**MODIFICATION REQUEST:
Bennelong Parkway, Wentworth Point
(MP09_0160 MOD 2)**

***Increased height, density and car parking for
approved residential development concept plan.***

Director-General's
Environmental Assessment Report
Section 75W of the
Environmental Planning and Assessment Act 1979

July 2013

Figure 3: Proposed modified heights in storeys (with approved heights in brackets)

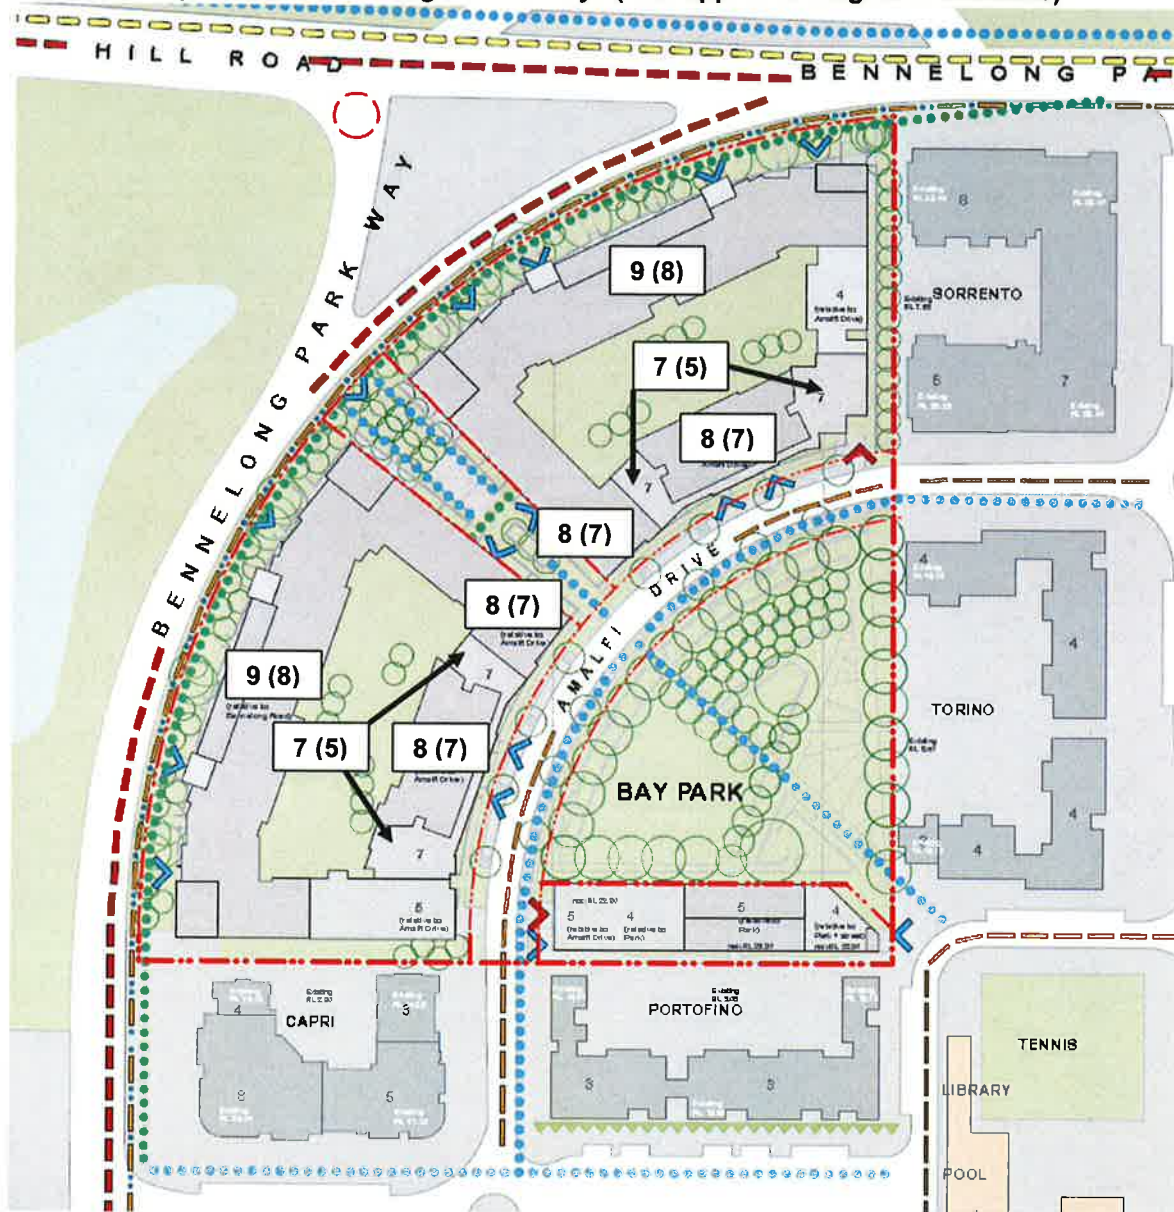
It is proposed to increase the height of Buildings B and C (refer to **Figure 3**) as follows:

- Eight storey components to increase to nine storeys;
- Seven storey components to increase to eight storeys; and
- Five storey infills to increase to seven storeys.

The Department's assessment of the Concept Plan generally supported the development and considered the building envelopes were an appropriate fit within the context of surrounding development, subject to a reduction in the height of the south eastern corner of Building B, facing Amalfi Drive, to five storeys. This was to ensure the development would be compatible with the height and scale of existing and adjoining buildings (refer to **Figure 3**).

The proposed modification complies with the DCP height limits except for the nine storey component which exceeds the height limit by one storey.

The nine storey component is located on the south-western edge of the site adjacent to the wide setback provided by the carriageways of Bennelong Parkway and Hill Road. This siting means there will be no unreasonable impacts on the development itself or adjoining residential flat buildings. Furthermore, the nine storey component will not result in any additional mid winter overshadowing of the neighbouring building to the south east or result in any unreasonable impacts on existing views and outlook from adjoining properties.

The modification request is considered a measured architectural and urban design response to the site's shape and location. The proposed nine storey component is aligned along the curved north western edge of the site on the corner of Bennelong Parkway and Hill Road and will further define the street edge and reinforce the gateway to Wentworth Point (refer to **Figure 3**).

Future Development Applications shall demonstrate high architectural quality breaking the overall mass of the building down into smaller building elements and through the use of a variety of textures, materials and colours to articulate the surface and reduce the visual scale of the nine storey component of Building B and improve its appearance from the street. This can include:

Figure 6: Separation of proposed nine storey component from neighbouring Capri building

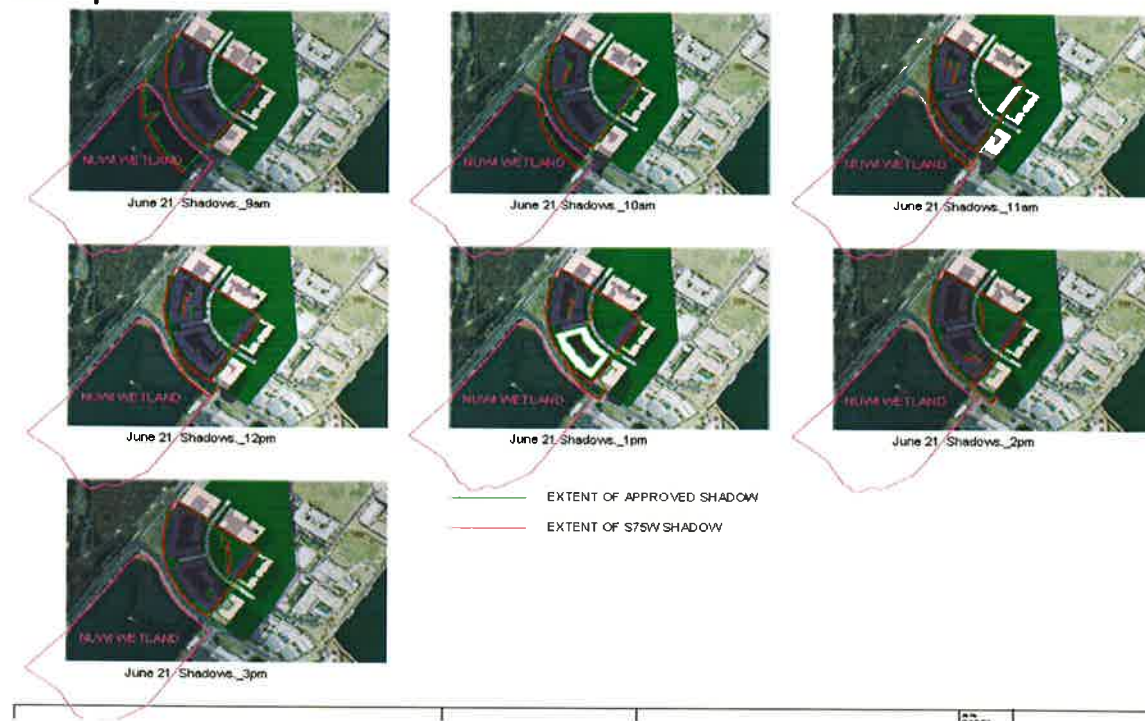
The proposed additional storey to Building B will not cause any additional mid winter overshadowing of the neighbouring Capri building to the south east (**Figure 5**) and will maintain existing views and outlook (**Figures 6 and 7**). The proposed modification would achieve compliance with the Residential Flat Design Code rule of thumb for 70% of dwellings to receive at least three hours of sunlight between 9 am and 3 pm at mid winter.

Figure 8: Views identified in Homebush Bay West DCP 2004

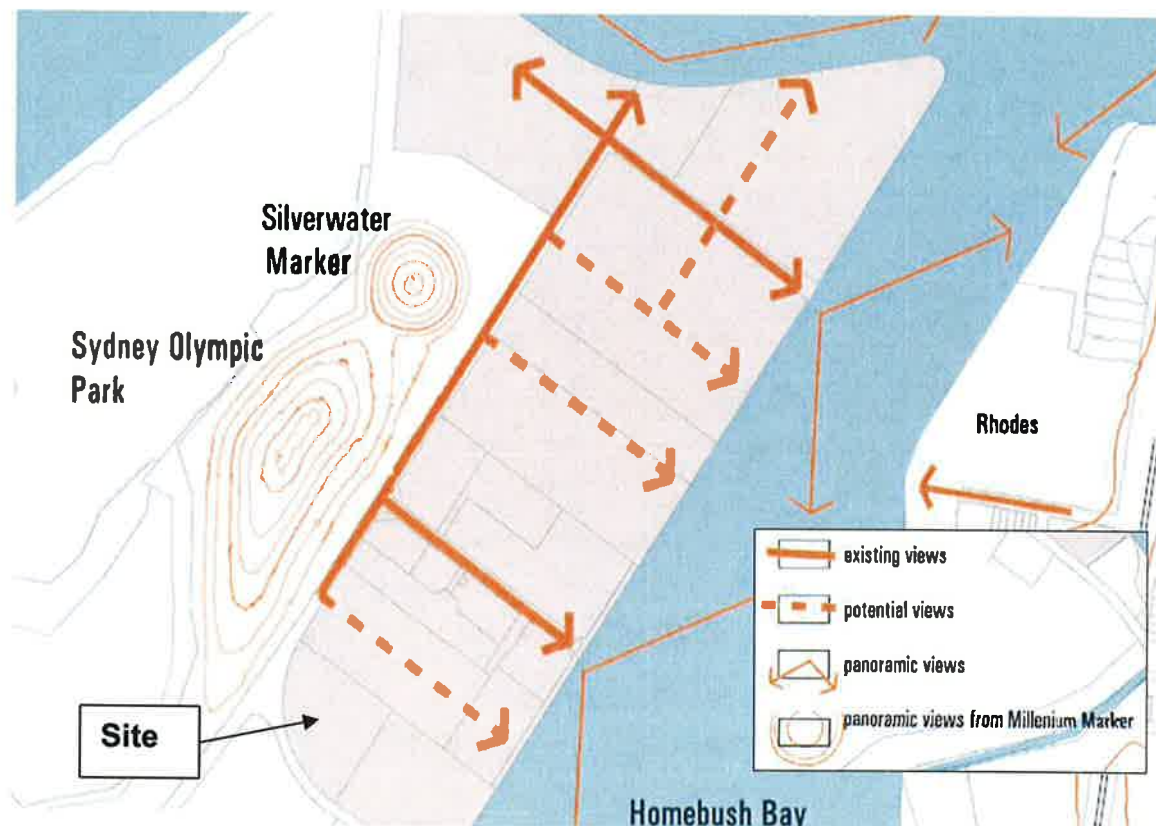
The DCP identifies views of value within Wentworth Point generally to the water and surrounding hills and along north-south and east-west corridors created by the new street network within Precinct F (see **Figure 8**). The site is located on the south western corner of the precinct, and the development as proposed to be modified will not result in any adverse impacts on the identified views.
